Change Order, Construction Manager as Adviser Edition

Christian County High School

Change Order Number: 097
Date: December 15, 2025

Project:	Christian County High School 5185 Ft. Campbell Blvd Hopkinsville, KY 42240	PR No.:	058
		Date:	September 2, 2025
Owner:	Christian County Public Schools 222 Glass Ave Hopkinsville, KY 42240	Project Number:	2106-204
		Contract for:	
To:	Kevin Hitchell Alliance Corporation 116 E. College Steet Glasgow, KY 42141		
RE:	Area J & G Modifications

FIRST FLOOR PLAN - AREA G

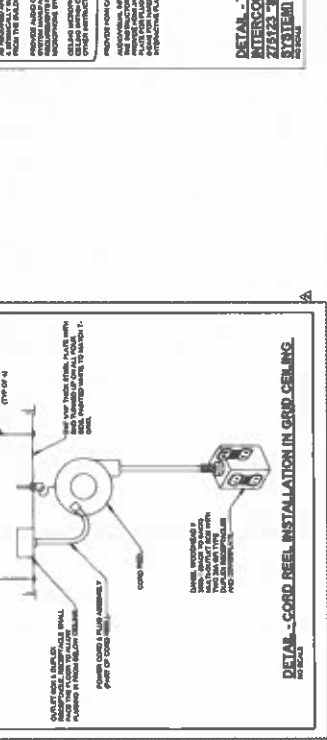
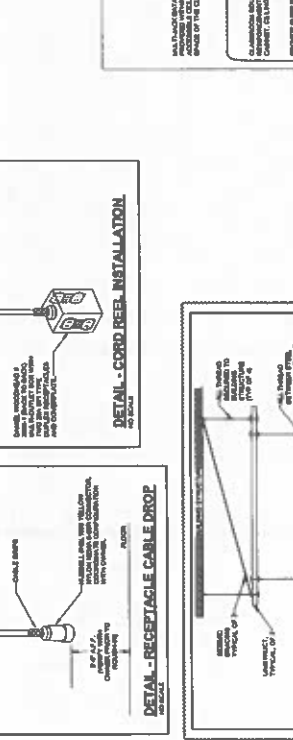
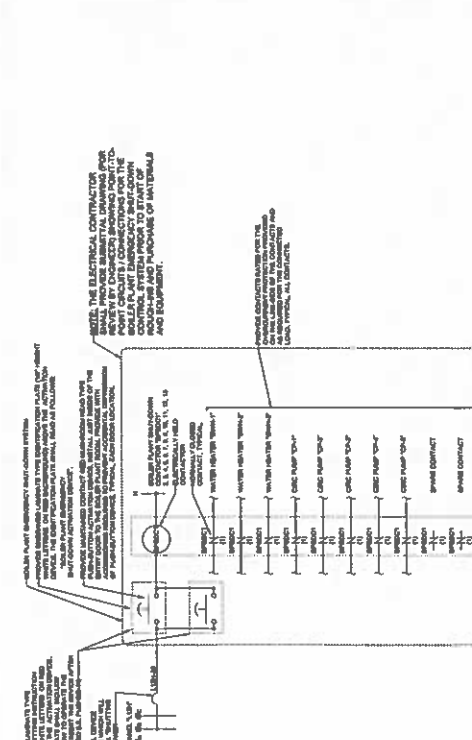
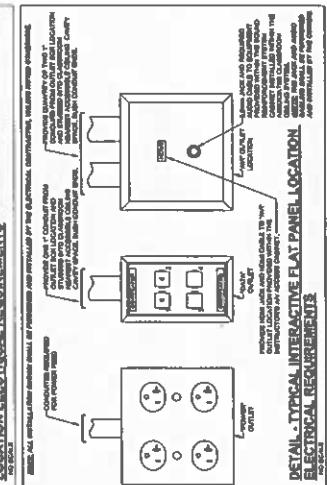
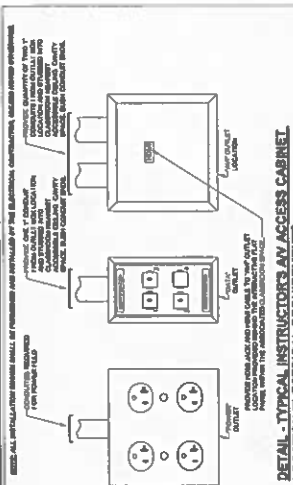
- 1) Classroom G106/G108
 - a. Delete the five IT casework stations. If stations have been manufactured, turn over to owner.
 - b. Do not install exposed cable tray in room.
- 2) Classroom G209:
 - a. Do not install foldable partition panels, keep track and bulkhead.
 - b. Remove wing walls for partition pocket. Patch bulkhead above, paint.
 - c. Remove casework from room. If casework has been manufactured, turn over to owner.

- b. Classroom G112. Changed power feed to receptacles within furniture system to receptacles installed within the wall.
 - c. Classroom G118. Changed power feed to receptacles within furniture system to receptacles installed within the wall.

- d. Added note G64.
- 6) Reference revised drawing E2.1H Rev. 5:
 - a. Construction Instruction J102. Changed power feed to receptacles within furniture system to receptacles installed within the wall.
